**Evaluation of the Proposed Pilot Groundwater Pump and Treat
Demonstration for the Paducah Gaseous Diffusion Plant**

Date Issued—November 1992

PADUCAH GASEOUS DIFFUSION PLANT

Fig. 2. Decision tree for source control of the Northwest plume.

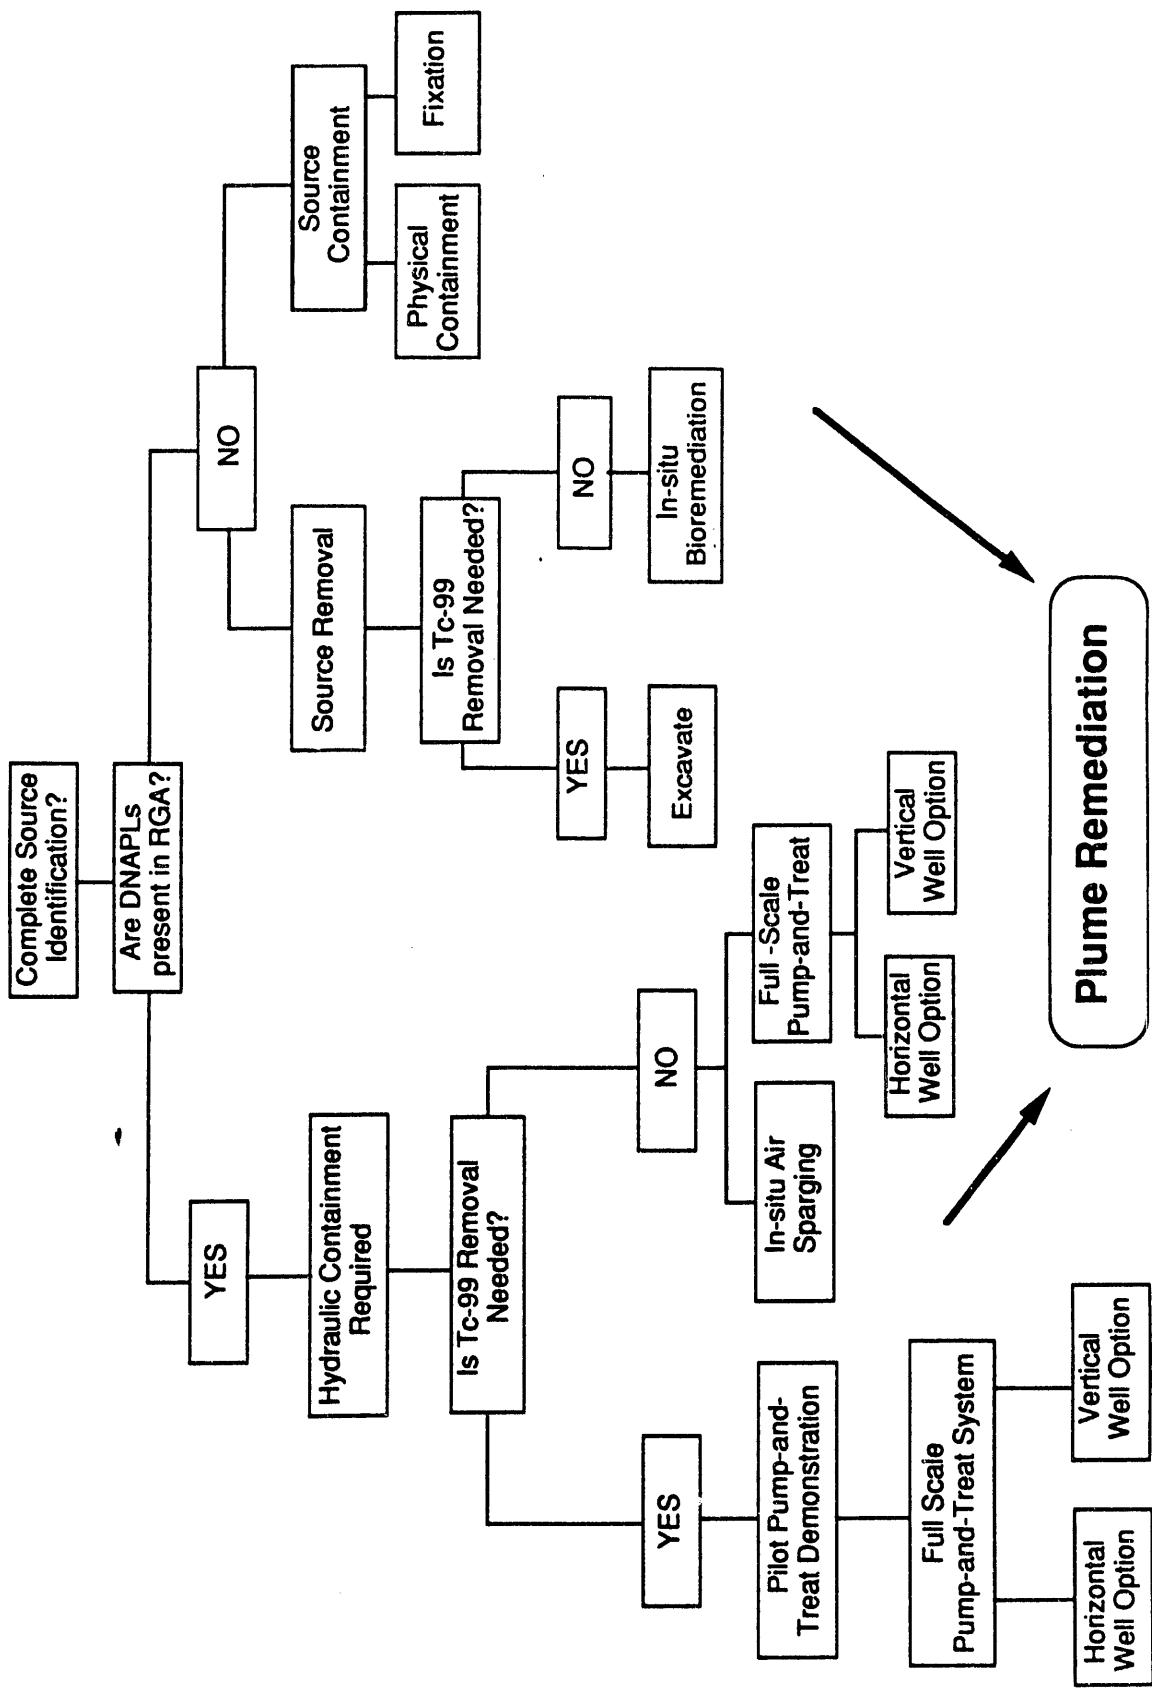
In the preparation of this report, the review team evaluated a broad range of technical data associated with the hydrogeology of the PGDP site as well as available remedial and treatment technologies. The team believes that there are two key questions that must be answered before final development of a comprehensive strategy for source control for the Northwest plume. First, are pure-phase DNAPLs that will act as a long-term source of dissolved TCE present in the RGA? Second, is removal of ^{99}Tc from groundwater a required part of the chosen treatment process? The first question cannot be answered without additional field work to better define the source(s) of the Northwest plume. The second question requires a decision, perhaps based upon a risk analysis, the determination of alternate concentration limits (ACLs), or established DOE policies. On the basis of these fundamental questions, it is possible to construct a decision tree to help guide PGDP in the development of a comprehensive work plan (Fig. 2).

In Sect. 3.1 we introduced a decision tree (Fig. 2) to assist in evaluating the key questions that must be addressed in choosing a defensible approach to source control for the Northwest plume. In fact, this decision process is generally applicable to groundwater at PGDP, and its use need not be restricted to this one area of contamination.

- Introduce a decision point into the proposed work plan that would follow the source characterization and small pilot-scale treatability demonstration. The decision would be whether to use removal or isolation for source control (if feasible) or to proceed with a hydraulic containment option.

Fig. 3. TCE and ^{99}Tc concentrations in groundwater from the upper RGA in the vicinity of the Northwest plume.

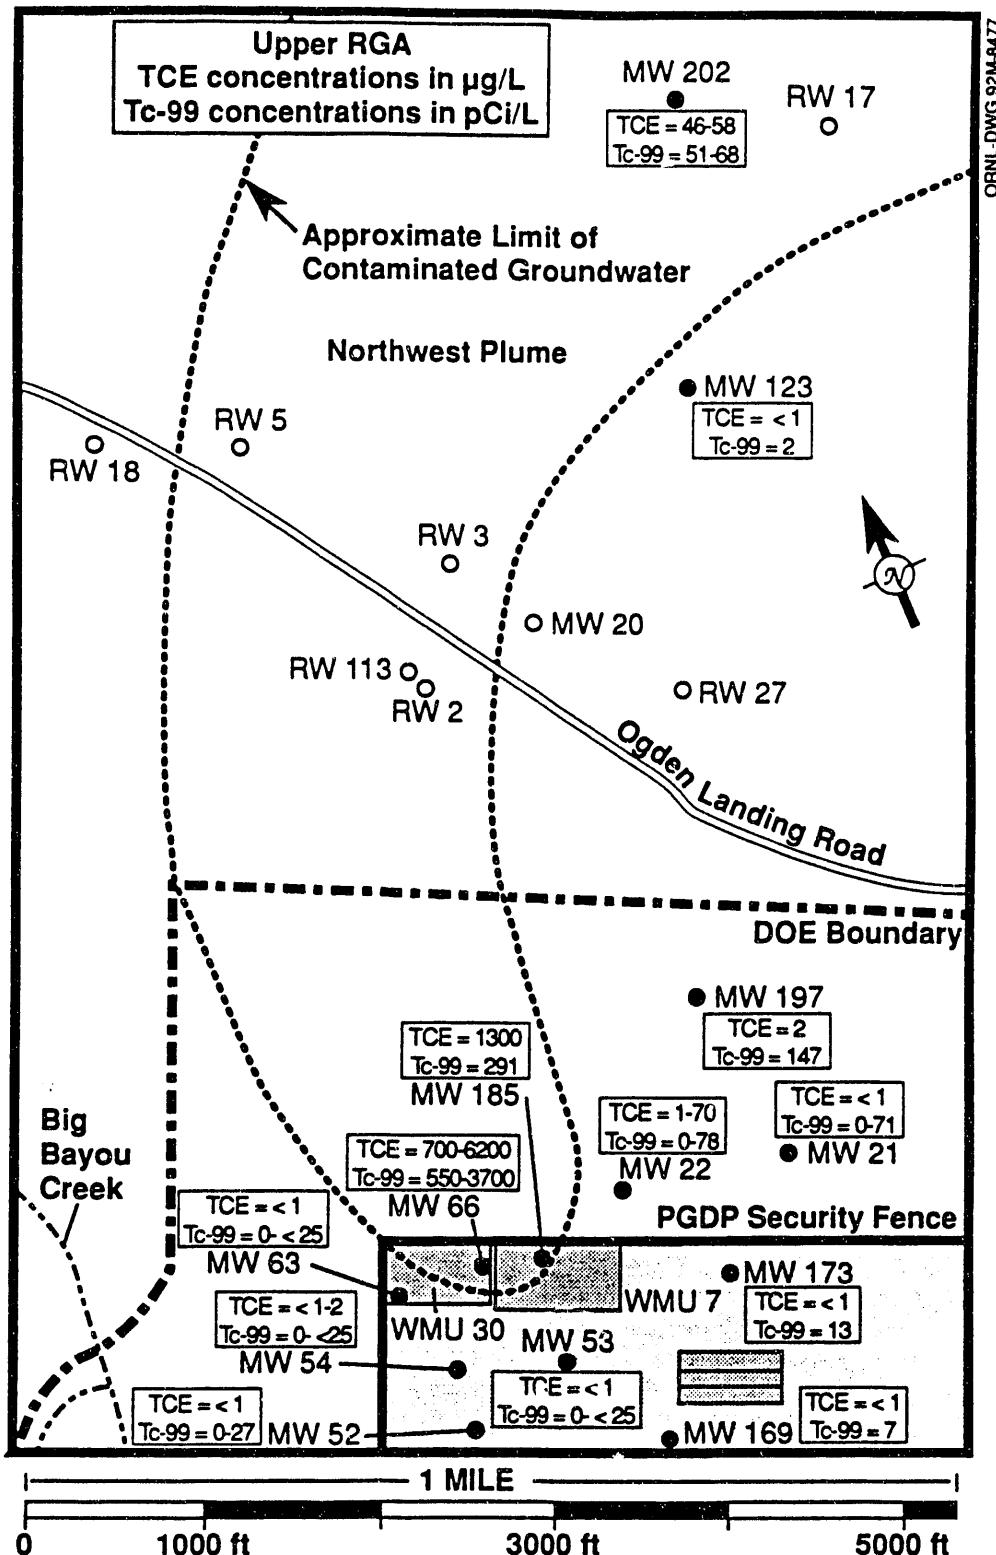
The bulk of the groundwater data for the Northwest plume has been collected from the RGA. However, even for this unit, inadequate coverage exists. Figure 3 illustrates what is known about contaminant distributions and concentrations in the upper part of the RGA. Residential wells in the area have been included in the figure for reference. Because of uncertainties about their completion depth, it is inappropriate to include these wells in a discussion of vertical distribution of contaminants in the RGA. However, available information suggests that they are screened within the RGA, and observed levels of TCE and ⁹⁹Tc in groundwater from them are consistent with data obtained from the high-quality monitoring wells screened within the upper RGA illustrated in Fig. 3.²

In general, data obtained from the upper RGA indicate that the source of both TCE and ⁹⁹Tc contamination in the Northwest plume is from the vicinity of WMUs 7 and 30. Although there are gaps between MW-63 and MW-54, MW-52 and MW-53, and MW-169 and MW-173 through which a narrow plume from another source to the south could pass, the evidence suggests that the contaminant source probably is localized to the northwest corner of the plant.

Rather than install additional, permanent monitoring wells to delineate the source area, a one-time sampling strategy using a modified hydropunch method is recommended. To distinguish these installations from conventional monitoring wells, the hydropunch monitoring facilities will be referred to as sampling stations. Hydraulically pushing a detachable drive point with smooth, flush-threaded drill rods (where the point has been machined to the same diameter as the rods) through a zone contaminated with DNAPLs will prevent creation of a micro-annulus around the rods and avoid possible mobilization of free product. Groundwater can be sampled at any point during the installation process. At the completion of the sampling activity, the drill rod is extracted simultaneously with grout injection; the drive point remains at the bottom of the hole.

Fig. 4. TCE and ^{99}Tc concentrations in groundwater from the lower RGA in the vicinity of the Northwest plume.

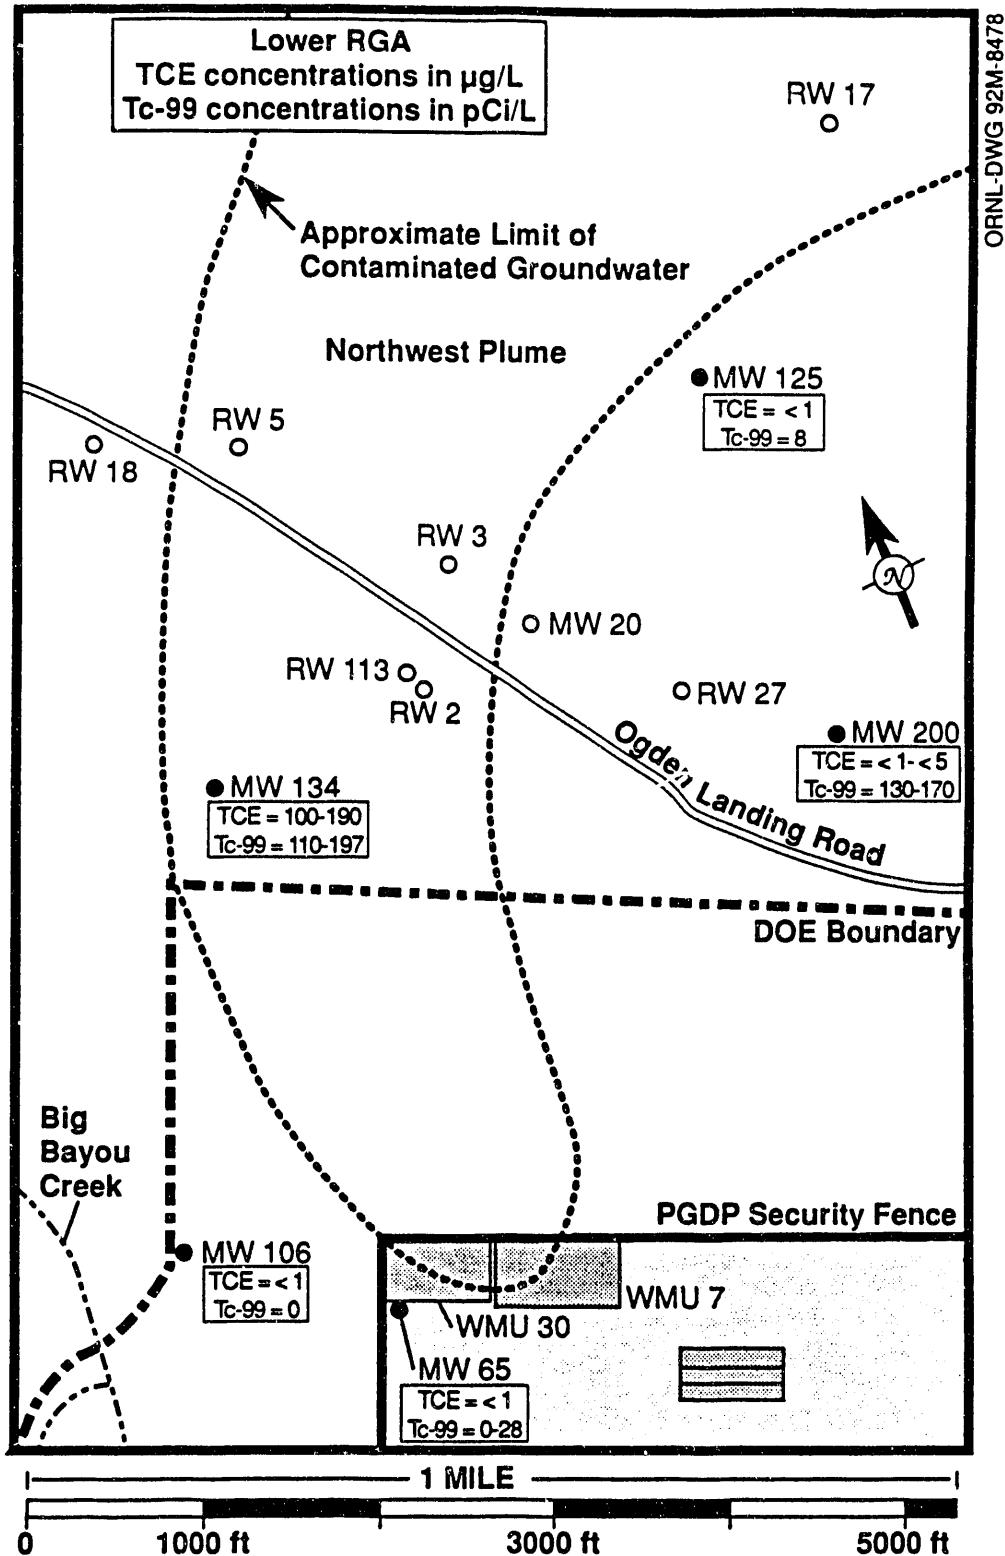
It is apparent why additional characterization data are required to differentiate among the scenarios listed above. If one can demonstrate that pure-phase DNAPLs, if present in the source area, have *not* migrated into the RGA, then a variety of source-containment options other than pumping and treating the RGA are possible. In contrast, if pure-phase TCE has migrated to the base of the RGA, a dissolved-phase plume will exist throughout the vertical extent of the aquifer. Therefore, confirmation of the existence of such a plume at the base of the RGA near the contaminant source area will be a strong indication that pure-phase DNAPLs have migrated at least to this depth.

Only limited hydrochemical data currently are available from the lower RGA with which to test this possibility (Fig. 4). Of the four wells screened at this stratigraphic level, only one (MW-134) shows any contamination, and it is located ~0.6 miles from the presumed source. It is essential that additional sampling stations are installed to the north (i.e., downgradient) of MW-66 to look for evidence of DNAPLs at the base of the RGA. Approximately three sampling stations located in a transect across the plume and several hundred feet north of the security fence should provide sufficient information. These stations should be installed by a modified hydropunch technology to permit collection of groundwater samples at multiple depths and to avoid the possibility of DNAPL migration if pure-phase material is encountered.

The SGS should be the shallowest zone sampled in these wells. Although there are questions about the continuity of the sand intervals that comprise this unit, it is desirable to better define the northward extent of contamination in it (especially if pure-phase DNAPLs are involved) before designing a source-containment system.

Fig. 6. Location of recommended sampling stations to characterize the contaminant source region for the Northwest plume.

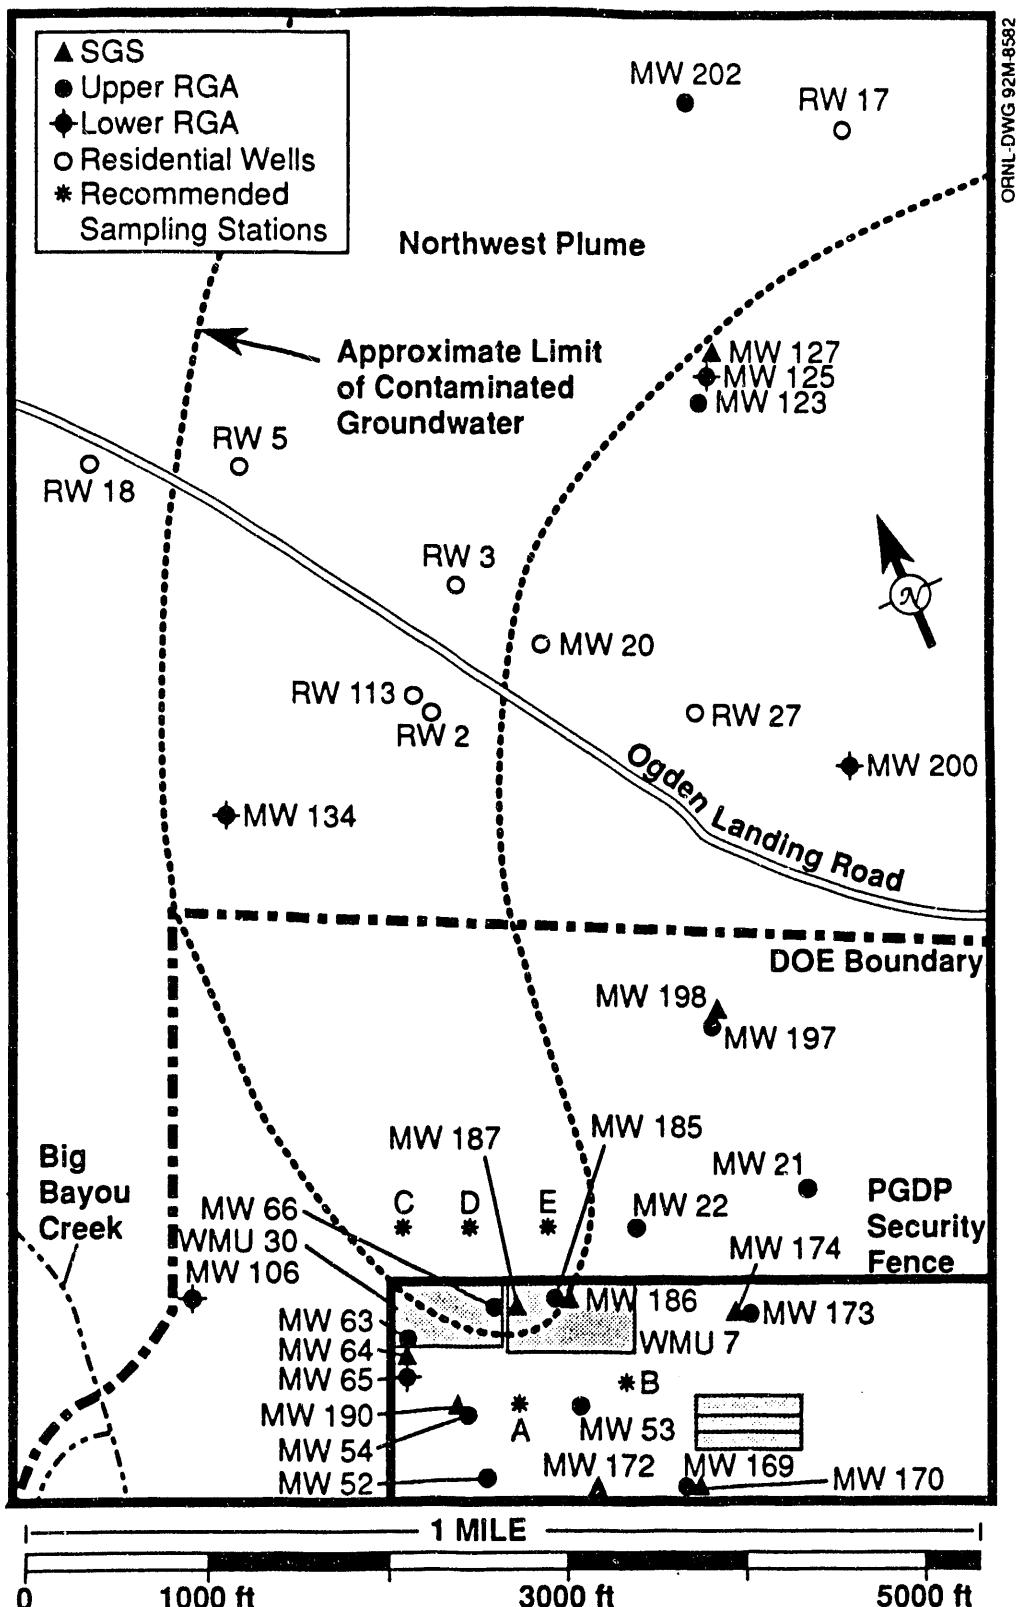
that another upgradient source is not a significant contributor to the Northwest plume. Figure 6 illustrates suggested locations for these sampling locations (sites A and B).

A necessary final step is the installation of additional sampling stations in those areas of the plume where uncertainties in its lateral extent persist. Examples of such areas of uncertainty are both the western and eastern margins of the plume from the northwest corner of the plant to a point north of Ogden Landing Road where the pumping wells for the pilot study are planned to be (Fig. 6). This information eventually will be needed to support future restoration decisions and activities.

The additional data outlined above can be incorporated into a hydropunch work plan currently in preparation by PGDP personnel. It may be necessary to modify the number, location, and completion depth for some of the sampling stations planned for this project to accommodate the recommendations in this evaluation report. For example, the five stations proposed in Fig. 6 are not included in the hydropunch work plan and are new installations. Furthermore, slight modification of the three transects proposed in the work plan will permit better definition of the lateral boundaries of the plume.
